Memorandum

SUMMARY OF
P050023/S048, P950037/S100, P000009/S047, P070008/S028
Lumax 700/740 ICD, Lumax 600/640 CRT-D, PSW 1102.U Programmer Software
Biotronik, Inc.

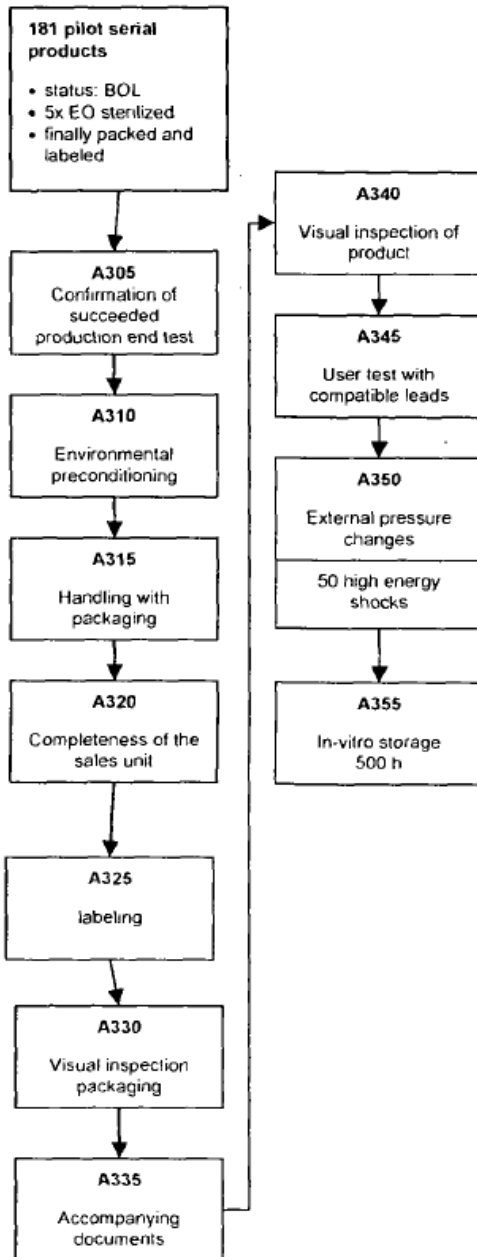
During the first round of verification and validation testing performed by the sponsor it was found that 2 devices failed the elevated pressure test. The problem was root caused to damage that occurred during the Environmental Preconditioning phase. It was determined that packaging did not provide enough cushioning for the devices. A revised package was established and the devices were subject to the Environmental Precondition phase 3 times. The preconditioning included the following:

Since the testing that found the failure (A350 in the chart above) was done later in the validation process the stress of testing may have brought marginal devices to failure. The retested devices may have exhibited the same failure. The retested devices only required visual inspection. It seems that the full validation cycle should have been completed on the repackaged devices to ensure that if the same device failure occurred it would be caught by testing.

The Environmental Pre-Conditioning test is the third test in their packaging test protocol. They reevaluated the packing material and placed the sterile blister pack between the labeling packet and the sterile cover. This provides additional cushioning of the device. The sponsor conducted the pre-conditioning tests an additional 3 times with the new

configuration and completed the rest of the protocol of testing. The testing was successful and all devices passed. The revalidation was performed with the same sample size as the original testing. The revalidation of the testing seems appropriate and the new method of packaging seems to be appropriate. There are no further concerns with this deficiency.
